**ADDENDUM NO. 2****Date of Issue: 1 February 2022**

Project: Renovations to Building 1000 Surgical Technology Lab  
Client: Horry-Georgetown Technical College  
State Project No.: H59-N085-PG  
DA Project No.: 21-106  
Prepared by: Doyle Architecture, LLC  
315 Main Street, Suite 2B  
Conway, South Carolina, 29526

SHEET:  
**A-120**

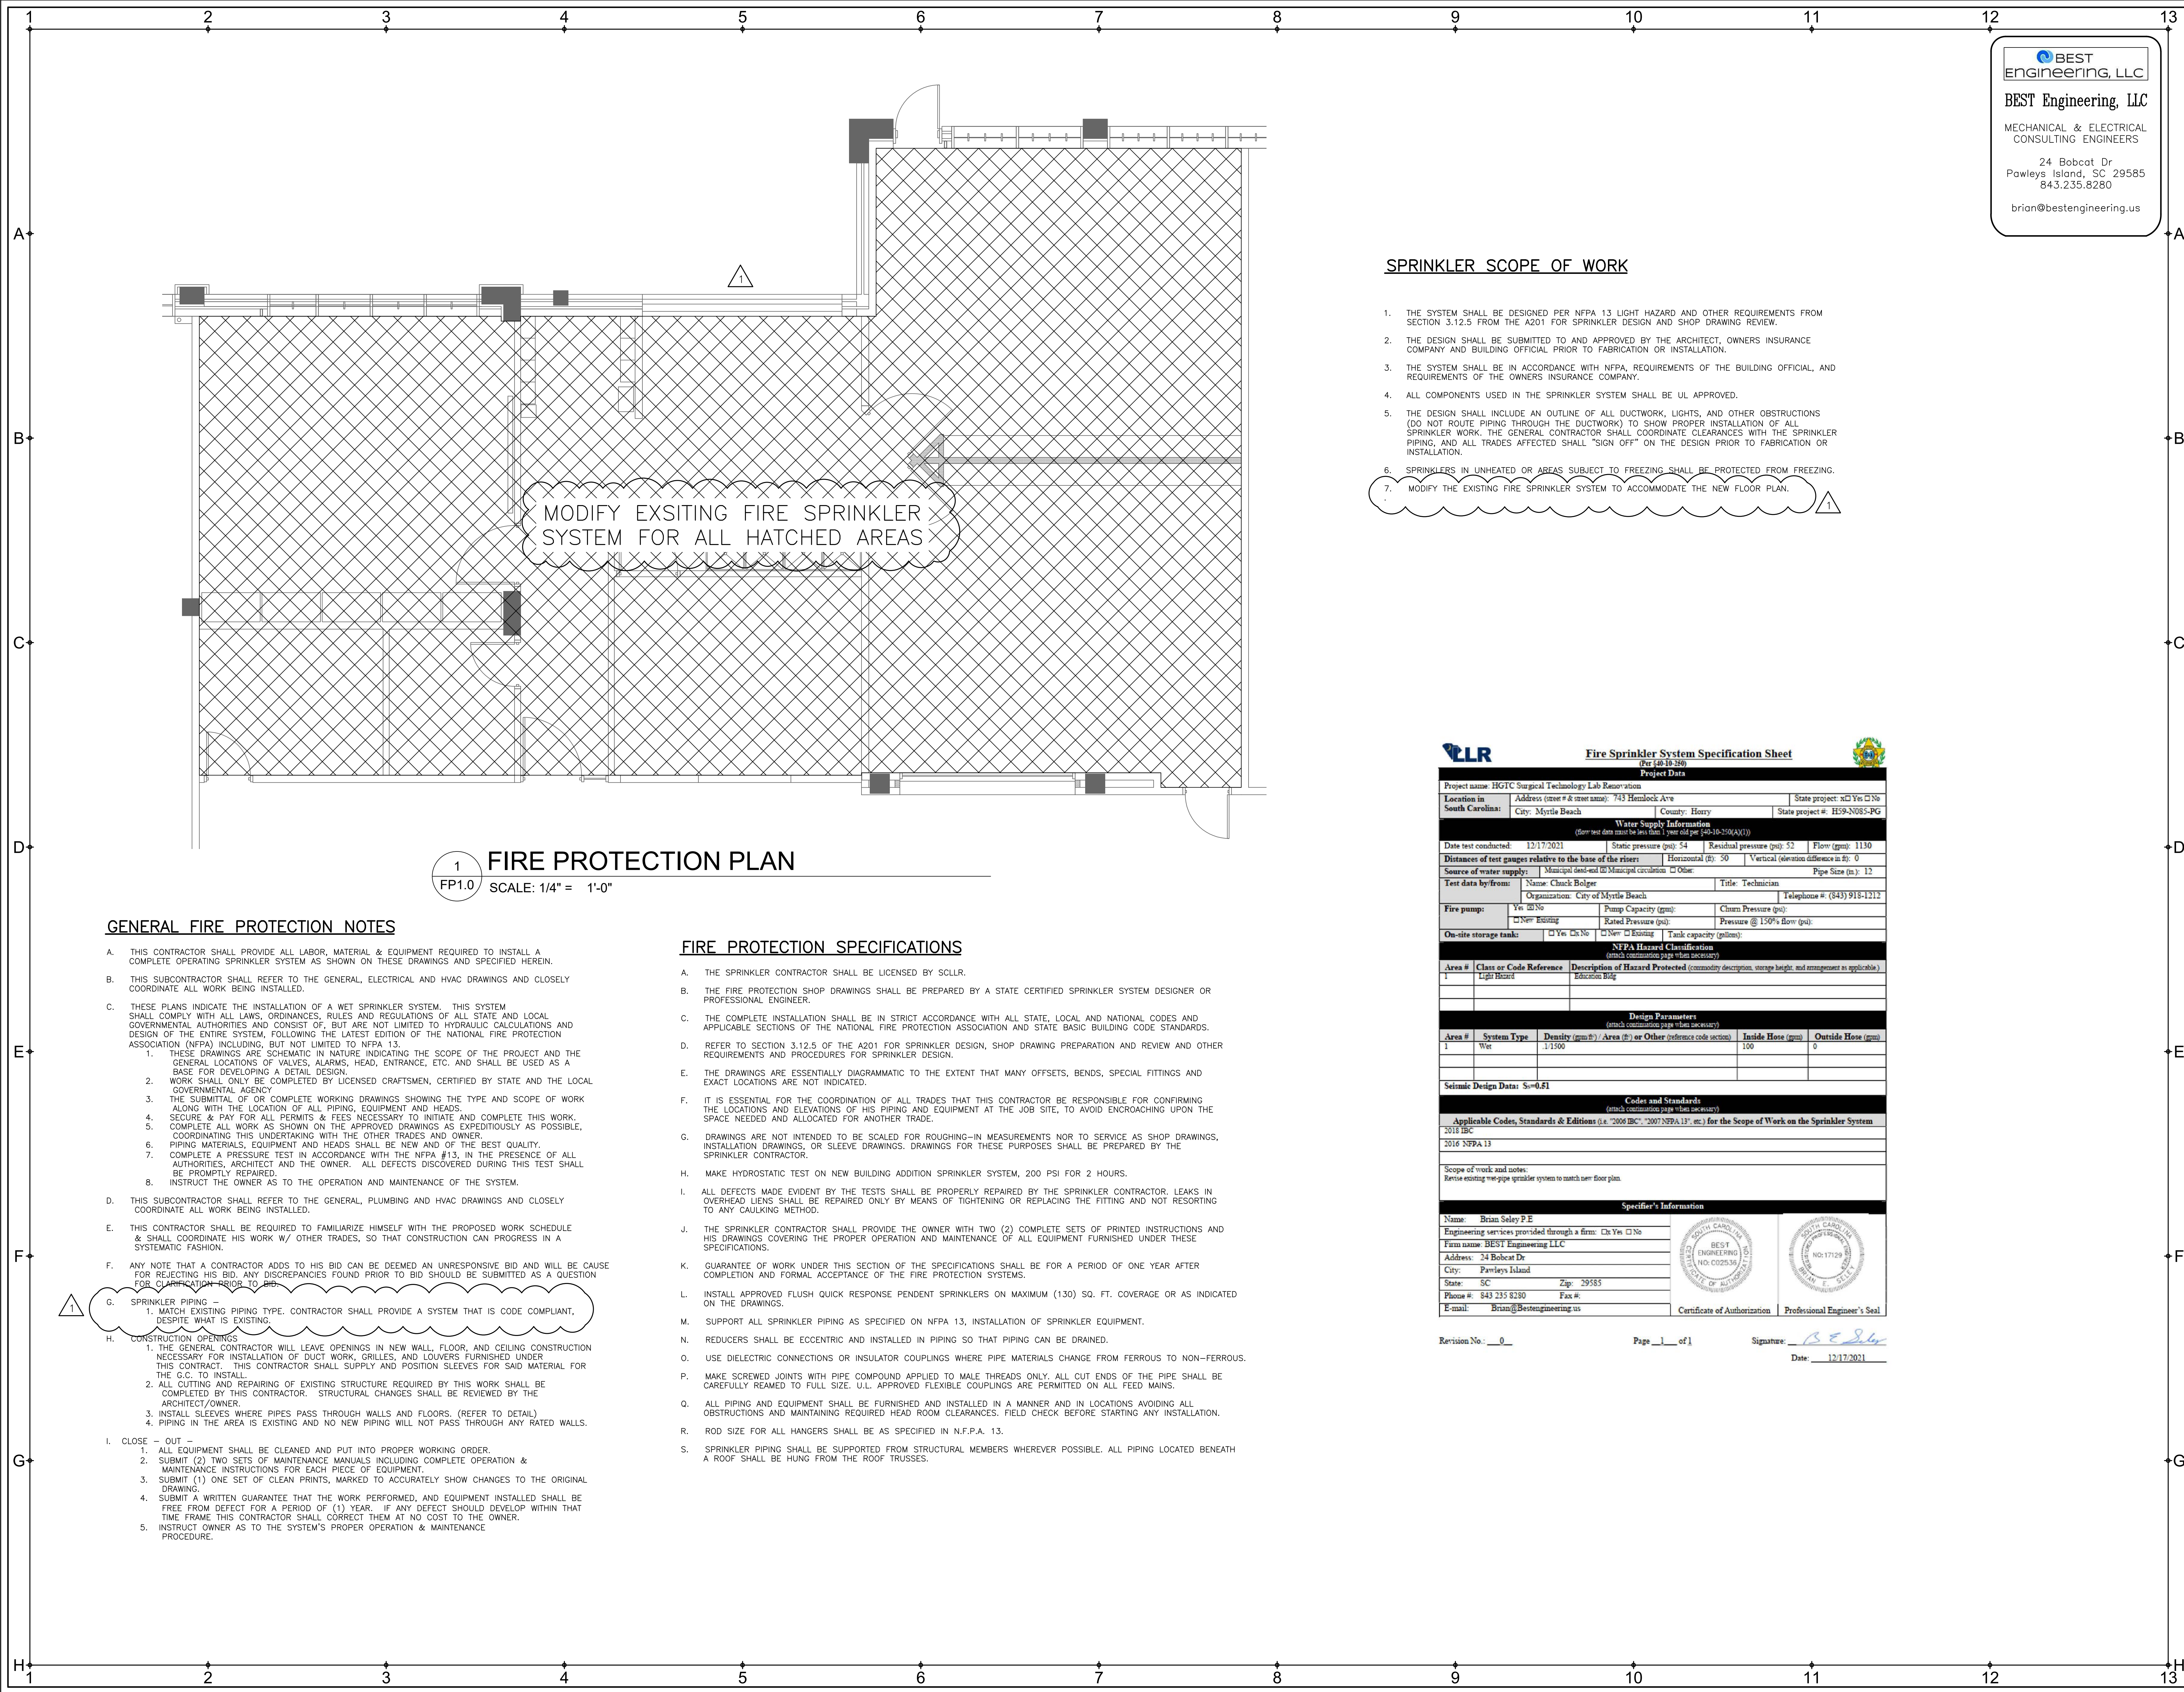
9. Sheet A-120: Furniture & Equipment Plan
- A. **ADD** a note clarifying the contractor’s responsibility regarding furniture and equipment as shown on the revised Sheet A-120 issued with this addendum.

NOTE: THE INFORMATION SHOWN ON THIS PLAN IS FOR REFERENCE ONLY. UNLESS INDICATED ELSEWHERE IN THE CONTRACT DOCUMENTS, THE FURNITURE AND EQUIPMENT SHOWN ON THIS PLAN IS TO BE OWNER-FURNISHED, OWNER-INSTALLED.

SHEET:  
**M1.0**

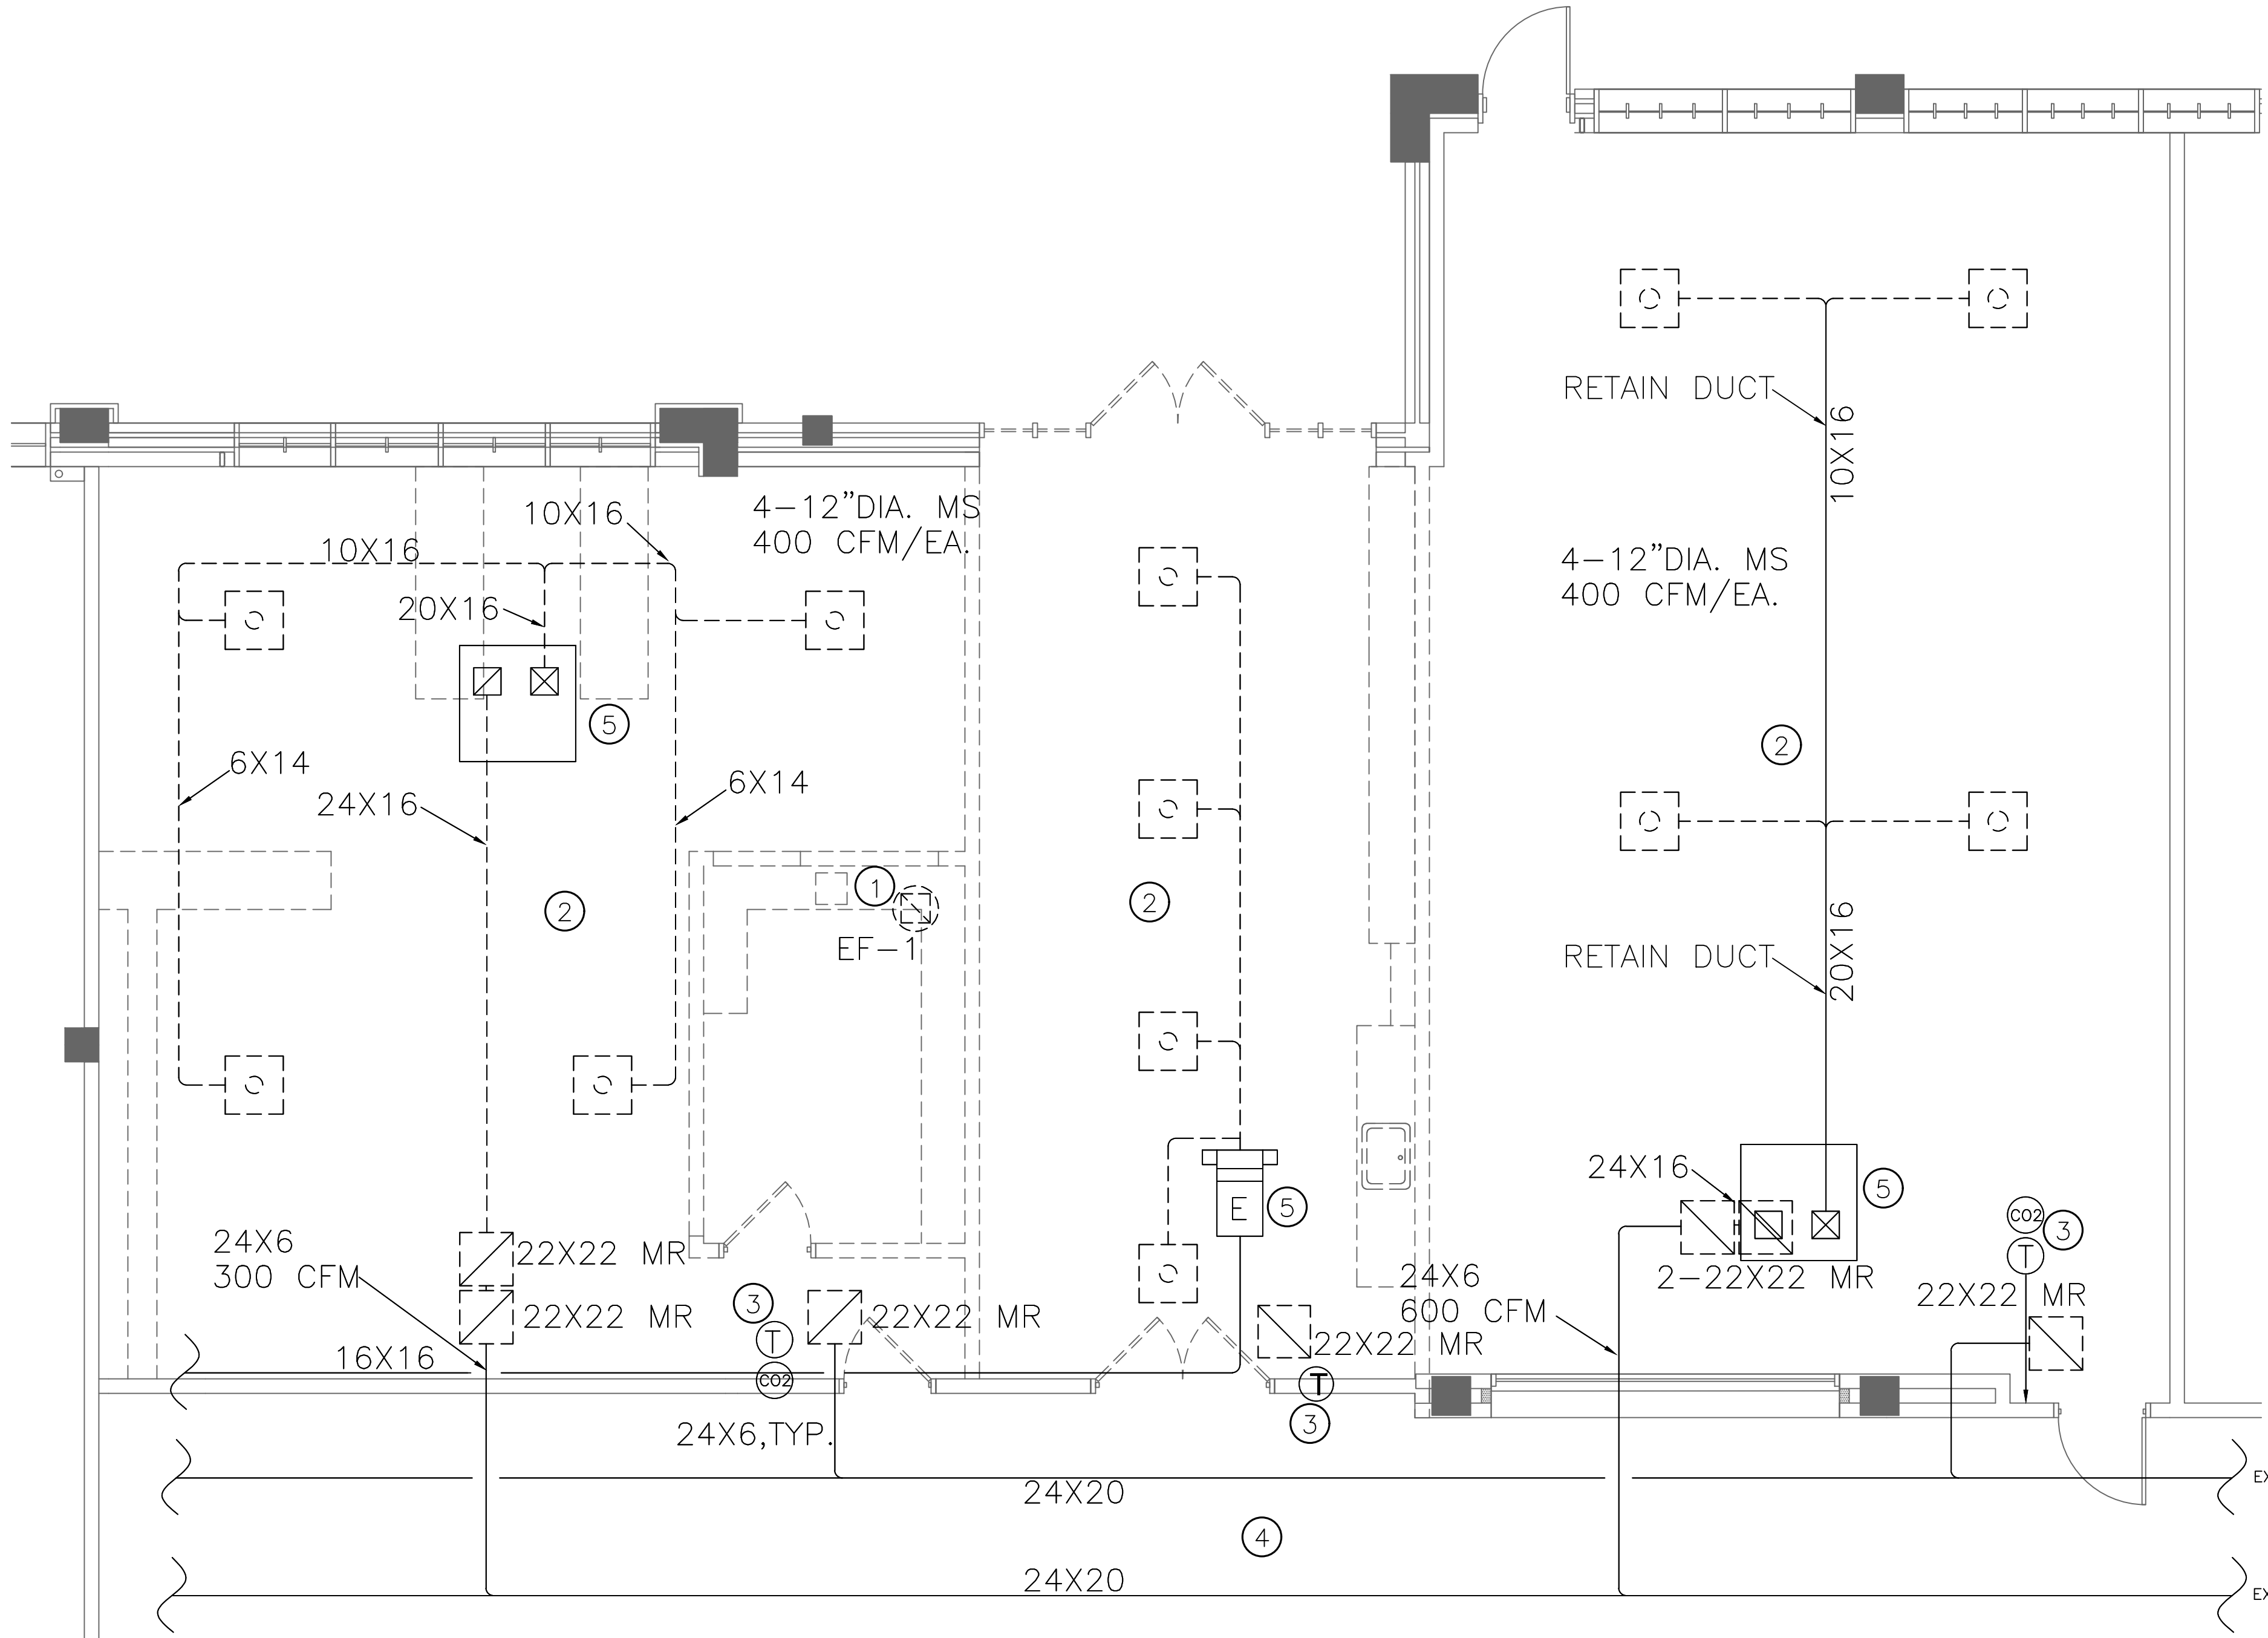
13. Sheet M1.0: Mechanical General Demolition Notes
  - A. **DELETE** Note 2 in its entirety as shown on the revised Sheet M1.0 issued with this addendum.
  - B. **DELETE** Note 4.4 in its entirety
